JEWELL RESIDENCE ADDITION

PETITION No.: V-109

TYPE OF VARIANCE: Waive the side setback from the required 10 feet to five (5) feet adjacent to the north property line.

COMMENTS

① SITE PLAN
1/32" = 1'-0"

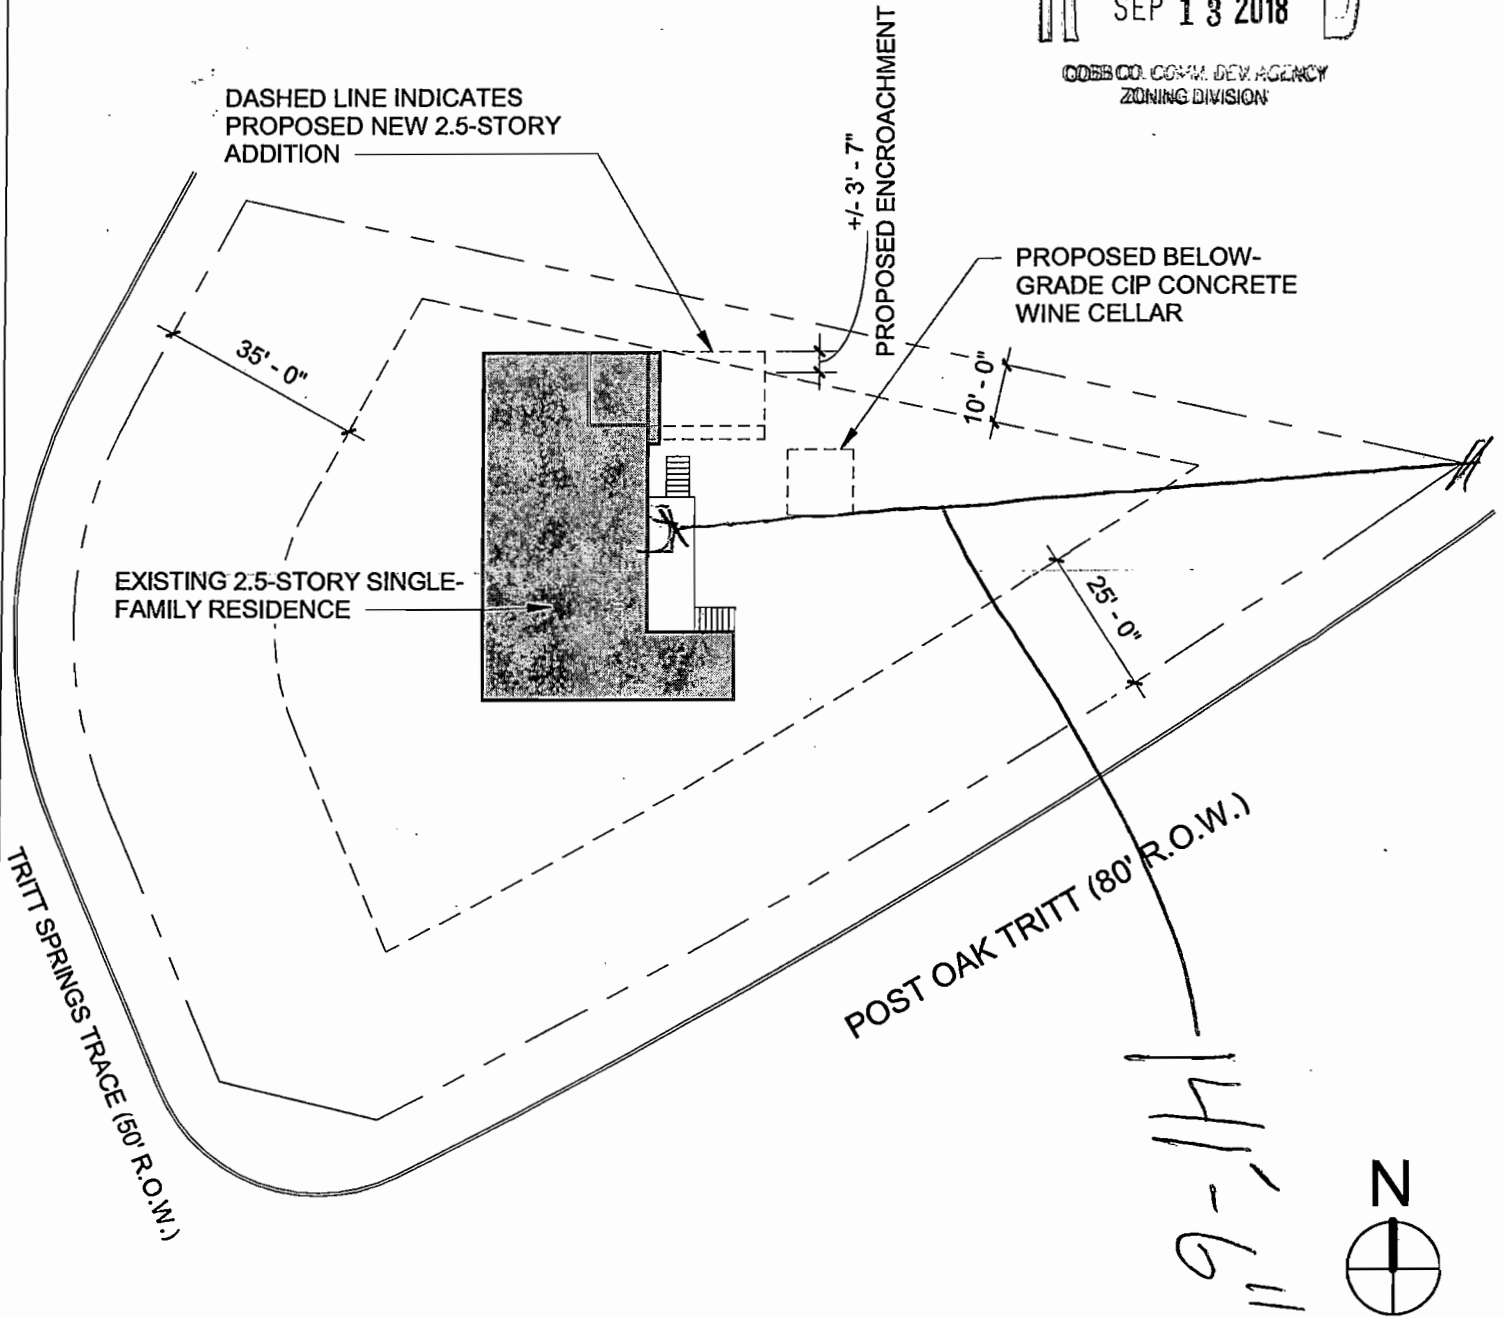
DEVELOPMENT & INSPECTIONS: Any wall closer than 5 feet to property line would be required to be 1-hour fire rated.

SITE PLAN REVIEW: If this variance request is approved, a subdivision plat revision must be recorded prior to the issuance of the building permit showing all improvements on the lot along with any approved setback reductions, and referencing the variance case in the standard plat revision note. The surveyor must submit the plat to the Site Plan Review Section, Community Development Agency for review and approval prior to recording. Call 770-528-2147.

STORMWATER MANAGEMENT: Subject to site grading plan approval by Stormwater Management Division. All downspouts for new construction must discharge to the front yard/street.
